Tuller Flats | Dublin, OH
Modification to Approved Windows

2015-07-16

Bldg FGJ @ Win. Head at Panels, Floor 3

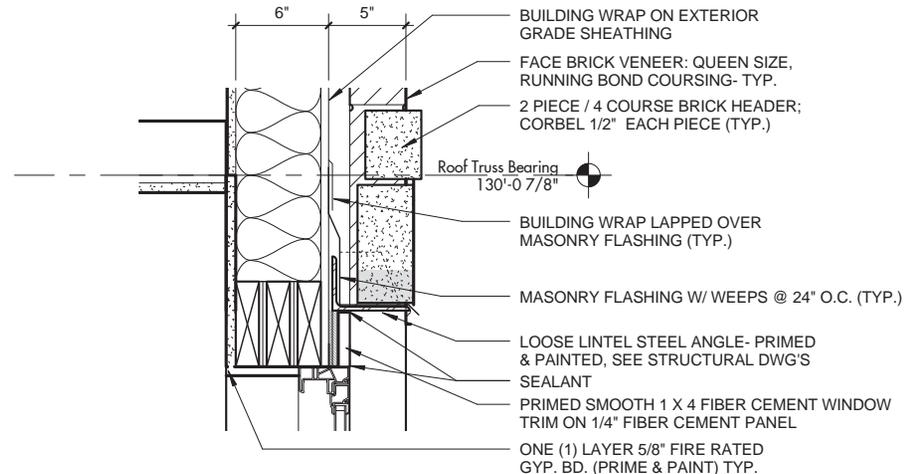
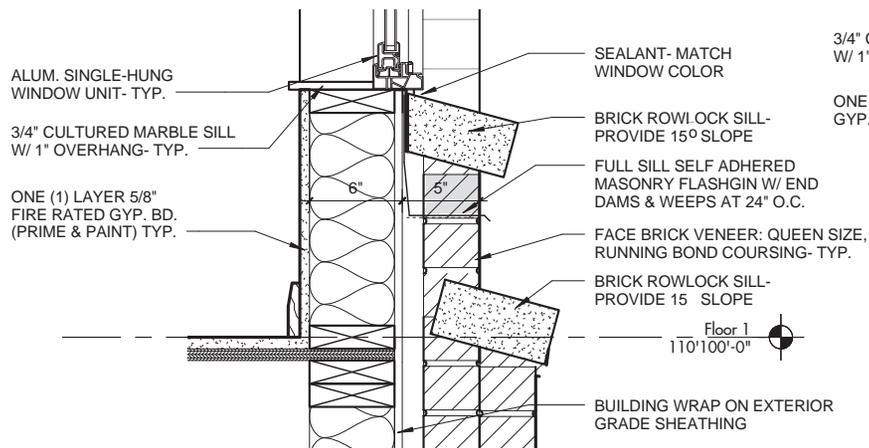
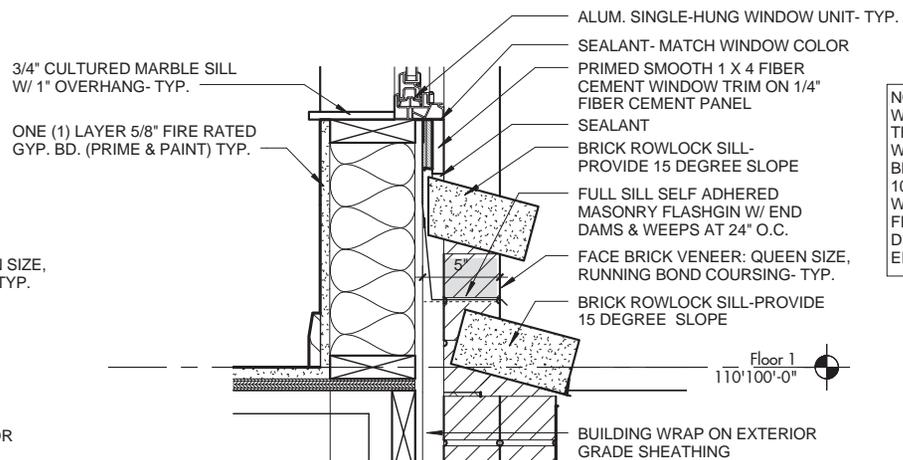
NOTE:
WINDWS CALLED OUT IN THESE DETAILS AS ALUMINUM WINDOWS ARE PROPOSED TO BE CHANGED TO ANDERSEN 100 SERIES COMPOSITE WINDOWS, BRONZE EXTERIOR FINISH. INSTALLATION DETAILS ARE SIMILAR FOR EITHER PRODUCT.

1 Window in 2-Wythe Brick Veneer
1 1/2" = 1'-0"

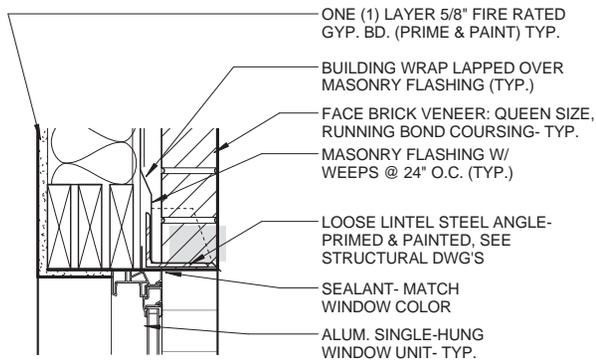
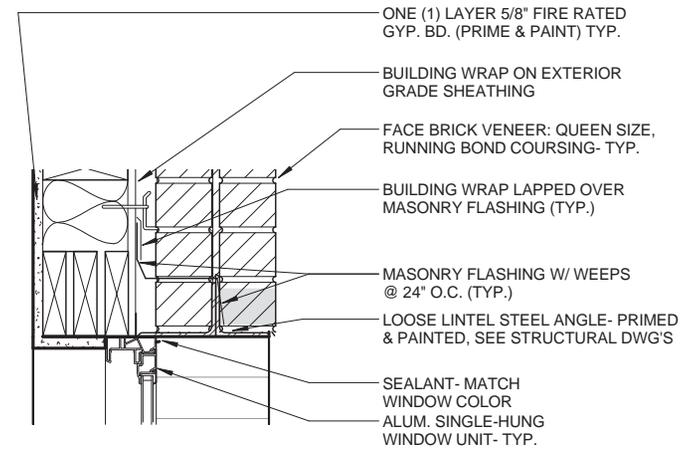
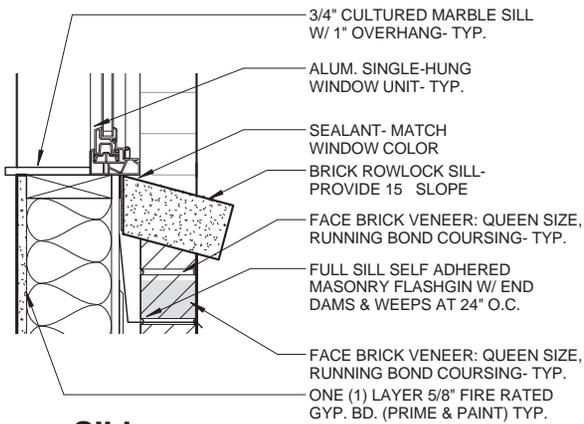
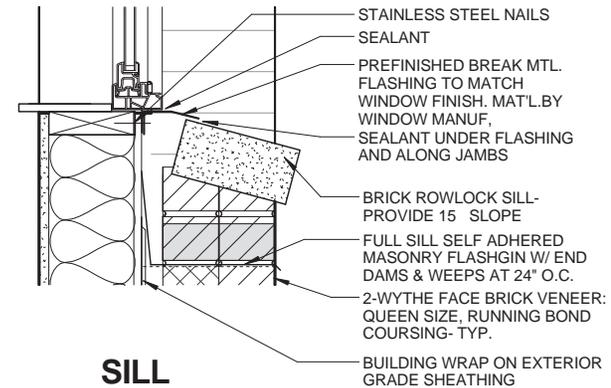
NOTE:
WINDOWS CALLED OUT IN
THESE DETAILS AS ALUMINUM
WINDOWS ARE PROPOSED TO
BE CHANGED TO ANDERSEN
100 SERIES COMPOSITE
WINDOWS, BRONZE EXTERIOR
FINISH. INSTALLATION
DETAILS ARE SIMILAR FOR
EITHER PRODUCT.

1 Window in Lap Siding
1 1/2" = 1'-0"

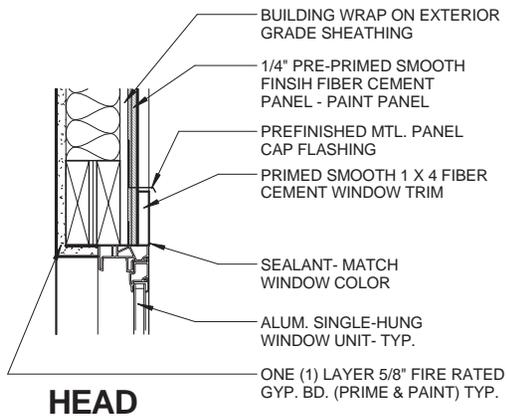
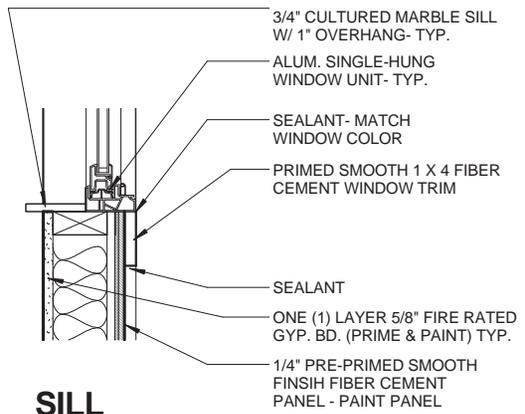
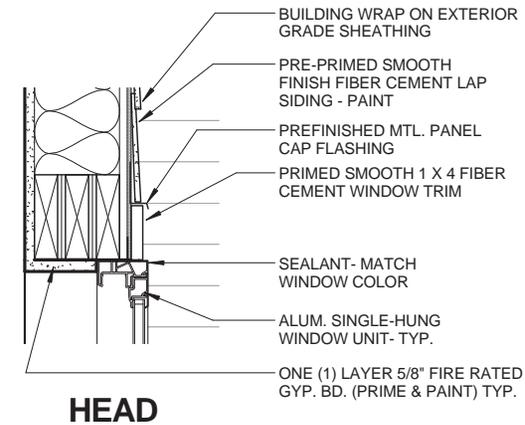
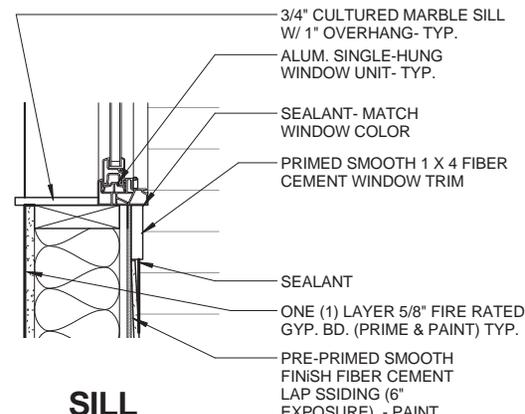
NOTE:
WINDOWS CALLED OUT IN THESE DETAILS AS ALUMINUM WINDOWS ARE PROPOSED TO BE CHANGED TO ANDERSEN 100 SERIES COMPOSITE WINDOWS, BRONZE EXTERIOR FINISH. INSTALLATION DETAILS ARE SIMILAR FOR EITHER PRODUCT.

1 Detail @ Building A + B Corner Siding
 1 1/2" = 1'-0"
 INSTALL SEALANT AT ALL JOINTS BETWEEN FIBER CEMENT PANEL CLADDING AND 1X4 PANEL TRIM

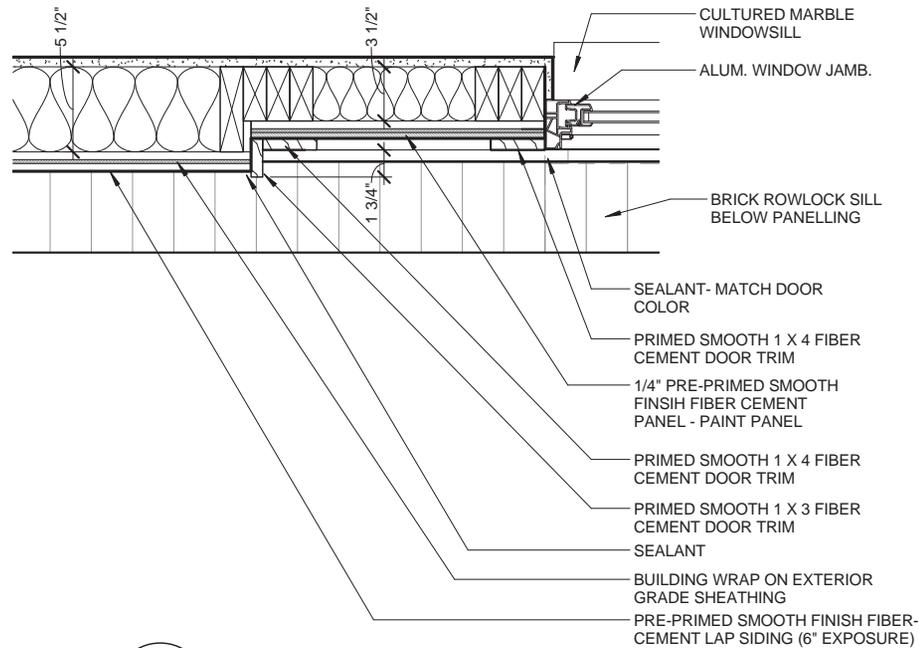
NOTE:
 WINDOWS CALLED OUT IN THESE DETAILS AS ALUMINUM WINDOWS ARE PROPOSED TO BE CHANGED TO ANDERSEN 100 SERIES COMPOSITE WINDOWS, BRONZE EXTERIOR FINISH. INSTALLATION DETAILS ARE SIMILAR FOR EITHER PRODUCT.
